## ***Interactive comment on “Identification of hydrological model parameters for flood forecasting using data depth measures” by T. Krauß and J. Cullmann***

**T. Krauß and J. Cullmann**

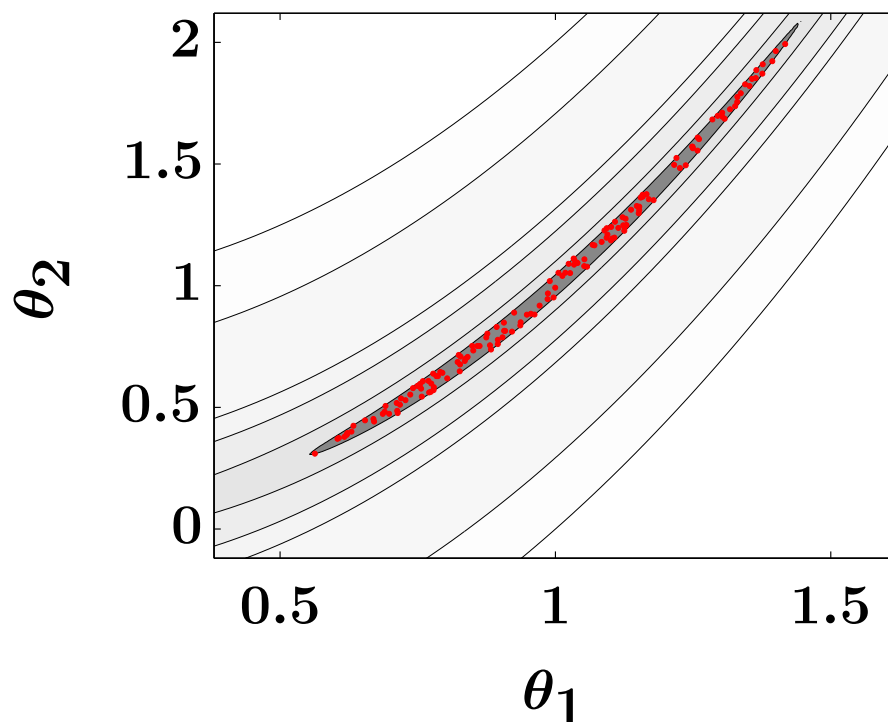
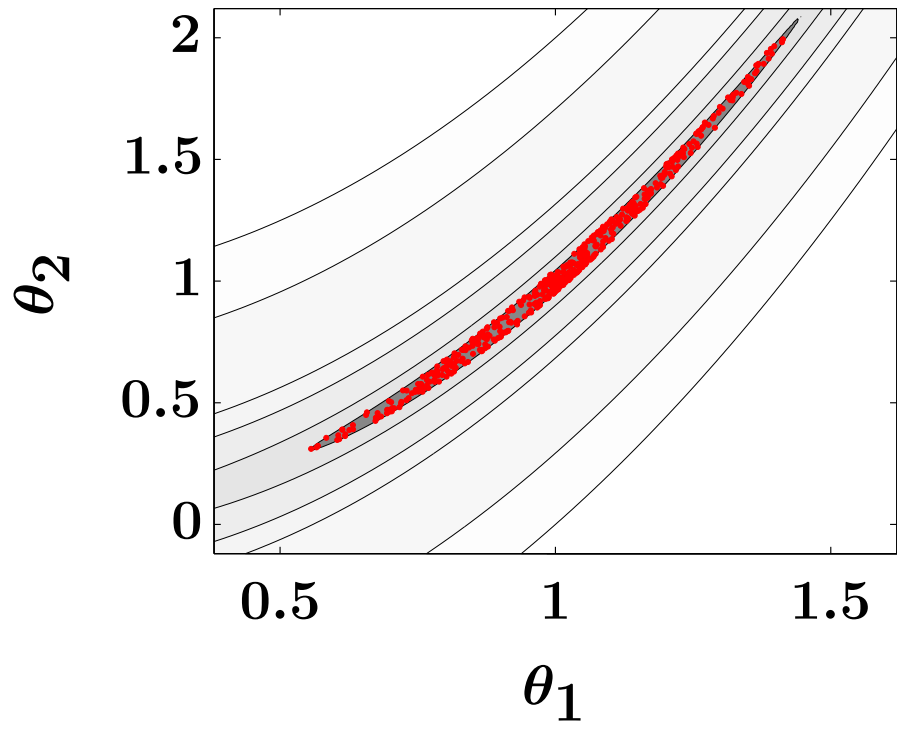
>PSO and other randomized search methods were not designed as uncertainty analysis methods. This means that the >vectors generated do not necessarily follow cover the space well and/or follow the prior distributions - which is >done by standard MC procedures. The objective of PSO and similar methods (like GA, ant colony optimization, >adaptive cluster covering, SCE-UA, AMALGAM, etc.) is to quickly move towards the global optimum, so that the >parameter space will not be thoroughly explored. There have been studies reported when such methods were >indeed used for uncertainty analysis as well, but there is of course no surprise they are more economical since >they are not geared towards exploration of parameter space. I would suggest providing some brief discussion on >this issue, or at least mentioning this. I would also suggest to provide references to the methods of “economical” >uncertainty analysis (sampling) that are combining ideas of on random search methods and MCMC Metropolis >algorithm (SCEM-UA, DREAM, etc) – see papers by Vrugt and co-authors.

We introduced a brief discussion on this issue into the introduction section. Furthermore we provide some results that support the ability of the developed PSO based approach PSO-GA\_u for the estimation of good parameter vectors within a larger region. They are presented in the course of the presentation of this method. Please refer to Figure 6a) and b) on page 10. We attached these figures to this comment as well.
